## Technical Bulletin – July 13, 2015

### 360 Y-DROP™ Z Bracket Warranty Kits

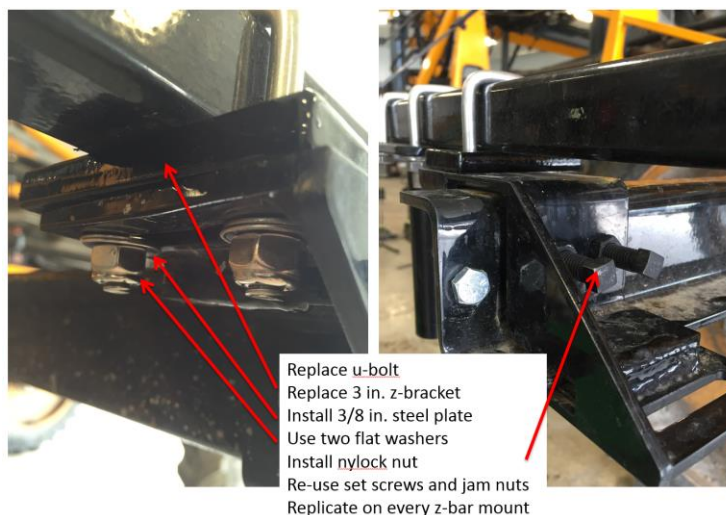
We have become aware of a possible issue that could lead to the Z bracket on the sprayer systems to become damaged and bent where it connects to the 360 Y-DROP boom. The square u-bolts may also loosen. See the photo below.

To help alleviate the possible issue, we have developed and sent you 360 Y-DROP Z Bracket Warranty Kits with the items necessary to reinforce the Z bracket and eliminate the issue. There are Warranty Kit options for 40 ft. (Part No. 411102), 60 ft. (Part No. 411100) or 80 ft. (Part No. 411101) booms, depending on the original install size. The Warranty Kits include:

- New Z brackets (same as original mount package; for replacement if your Z bracket is damaged)
- New u-bolts (same as original mount package)
- 3/8 in. thick by 3 in. long steel plate to place between the Z bracket and the 360 Y-DROP boom
- Double washers to use with the u-bolts
- Nylock nuts to use to keep the u-bolts tight
